MANCHESTER CITY COUNCIL

MCC Scheme Ref: 210449H

Scheme 210449H – Collyhurst South, Winscombe Drive, Manchester, M40 7FF – 4th Technical Review.

Following consultation and to recent correspondence submitting design drawings for technical review, we comment as follows:

~~**Drawing No. 1226-05-CIV-XX-XX-DR-HI-0301-P03-General Arrangement**~~
221625-EDGE-STH-XX-DR-C-3009_GENERAL ARRANGEMENT, Revision P03

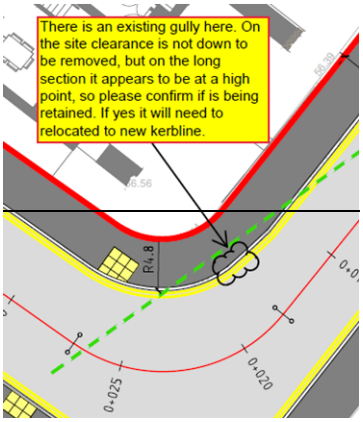
17. Having further considered the drainage channel at the back of the footway on the proposed section of Kingsfold Drive, we believe this has the potential to be a hazard where it crosses in front of the existing footpath access points at the existing properties, so we cannot accept this as a solution. However, having looked at the design there may be scope to reverse the fall of the footway back towards to the carriageway by altering the falls of the footway and adjacent layby section of the carriageway. Please call me to discuss options to change this.
Design updated; fall reversed.
Comment Closed.

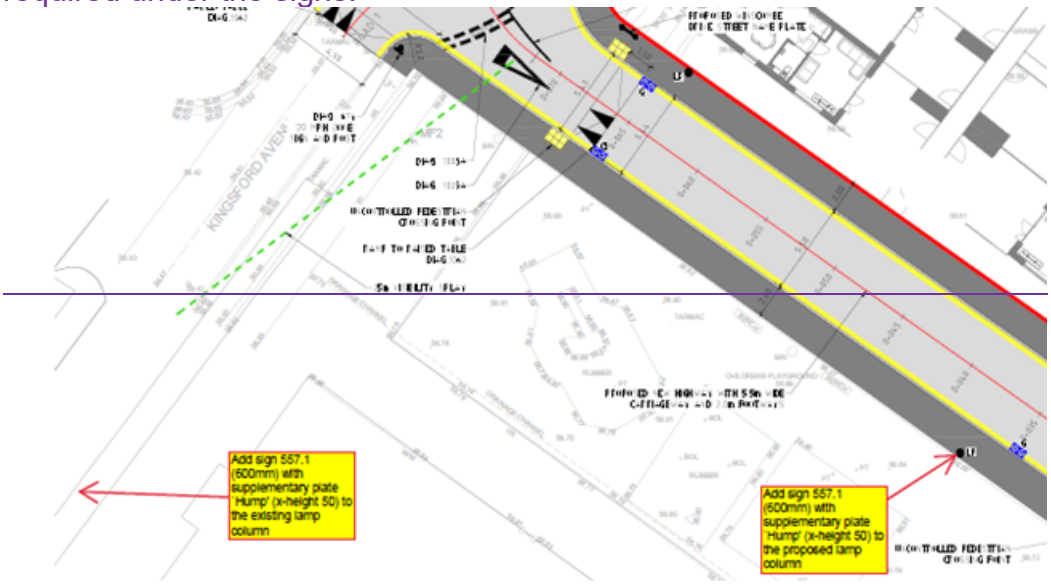
21. ~~Annotation missing at proposed sign on southside of Ramp where Existing Kingsfold Ave meets Proposed Winscombe Road. Please add.~~
~~Drawing updated accordingly.~~
~~Please add sign 557.1 (600mm) with supplementary plate 'Hump' (x-height 50) to the lamp columns indicated below. Please annotate that 2.3m of headroom is required under the signs.~~

The sign shown on the Kingsfold approach is floating in space. This is due to the extents the OS mapping on the drawing. For context, please add kerb lines that fill the gap. This does not need to absolutely accuate, but It will provide context to the proposed position of the sign in relation to the existing highway layout.

Signs added

Lines for context added, please confirm it's ok.

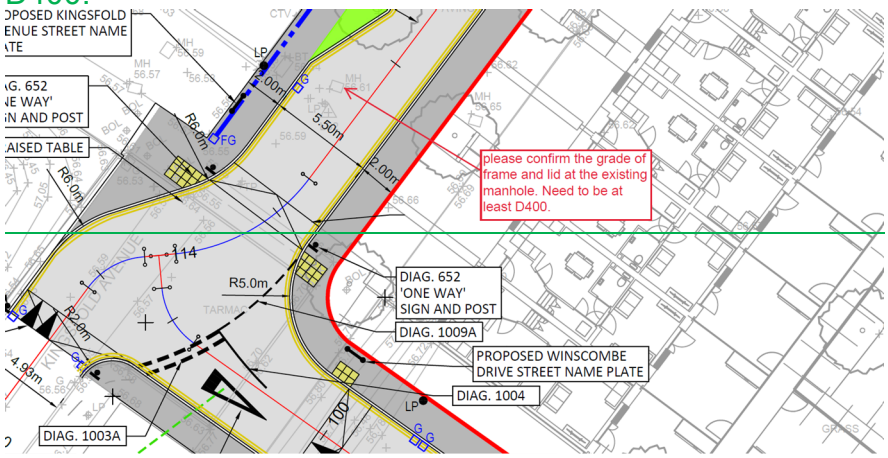
22. These is an existing manhole on the proposed new section of carriageway at Kingsfold Ave – see below image for location. Please confirm the current cover and frame weight class is sufficient to be used in carriageway. Need to be min D400.

This will be confirmed on site and upgraded to D400 (if required), and cover reset to proposed finished levels.

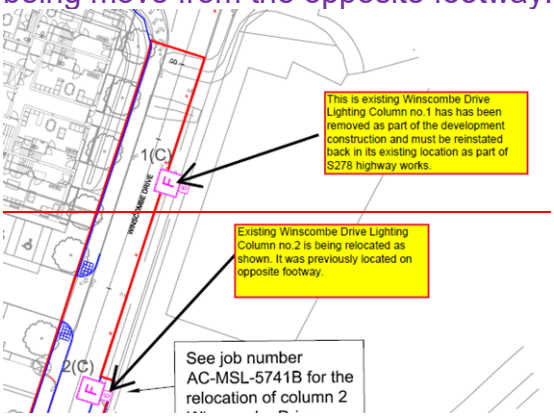
24. The raised table ramps are too long. Please update the length in line with MCC standard details C14.

The triangle marking dia 1062, should be the length at the ramp. Please update.

Ramps redesigned accordingly.

Ramp markings updated.

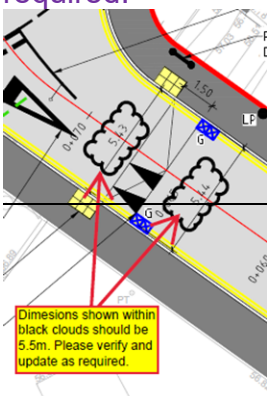
27. It is noted that some of carriageway dimensions are incorrect, refer to image below. The minimum carriageway width shall be 5.5m. Please update as required.

Dimensions amended.
Comment Closed.

~~Drawing No. 1226-05-CIV-XX-XX-DR-HI-0302-P3-Site Clearance~~
221625-EDGE-STH-XX-DR-C-3011_SITE CLEARANCE, Revision P02

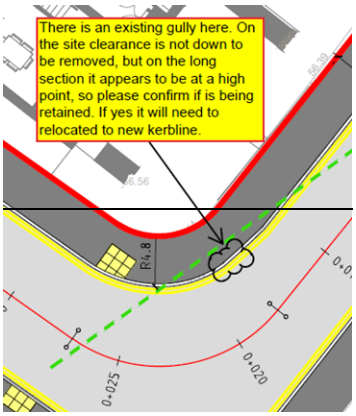
10. ~~Please confrim if the existing highway gully on Wiscombe Road shown within the black cloud below is being removed? Update drawings as required.~~

~~Gully marked as to be removed in the relevant drawings.~~
   ~~Comment Closed.~~
